**Hello everyone. We have upgraded our Thermal Camera firmware to V5.5.26 build200507 which is the latest one so far. The followings are some highlighted upgrade points since V5.5.26 build200427:**

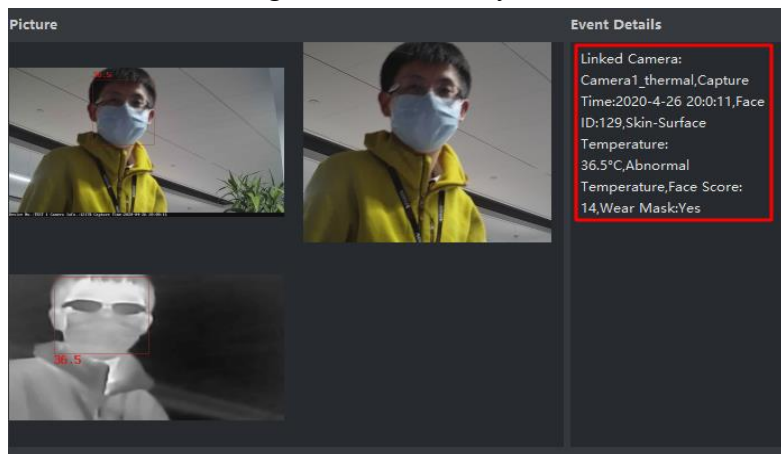
2. We now offer an option of **Italian** for **Temperature Measurement** alarm sound.

Note:
You can choose different alarm sound other than English for **Temperature Measurement**. But English is the only choice for **No Wearing Mask** alarm sound.

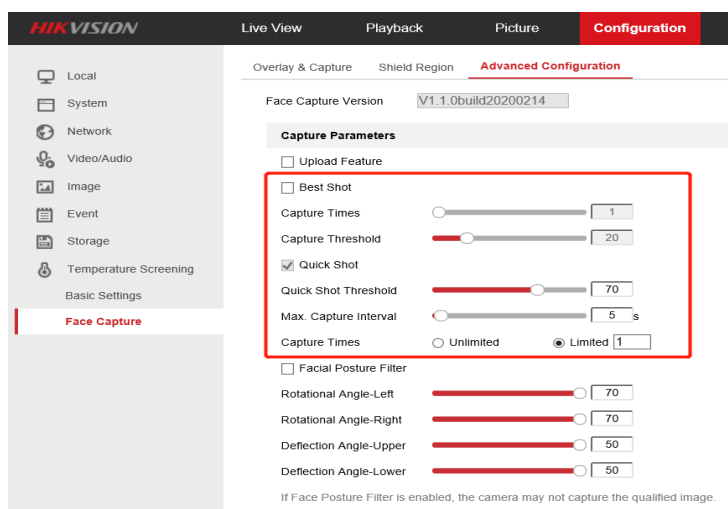
4. The Logic of face capture is optimized, and add **Best Shot** Mode additionally. The Program logic are set as following:

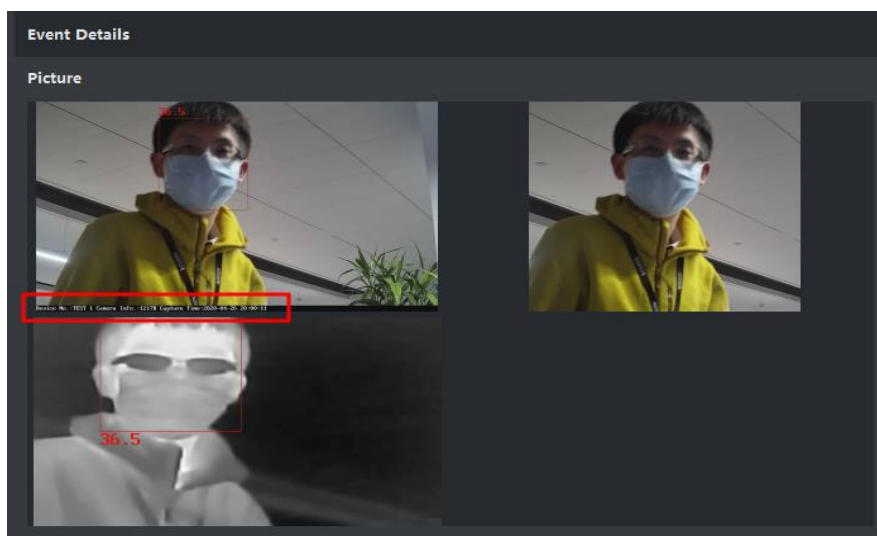
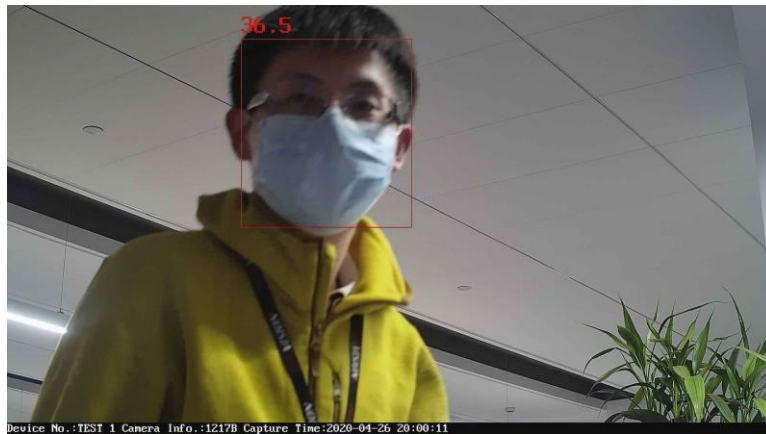
Best Shot：

① If the image quality reaches the Capture Threshold, when the object leaves the detection region, face picture with highest face quality score (it should reach the Capture Threshold, otherwise no picture would be uploaded) will be uploaded immediately;
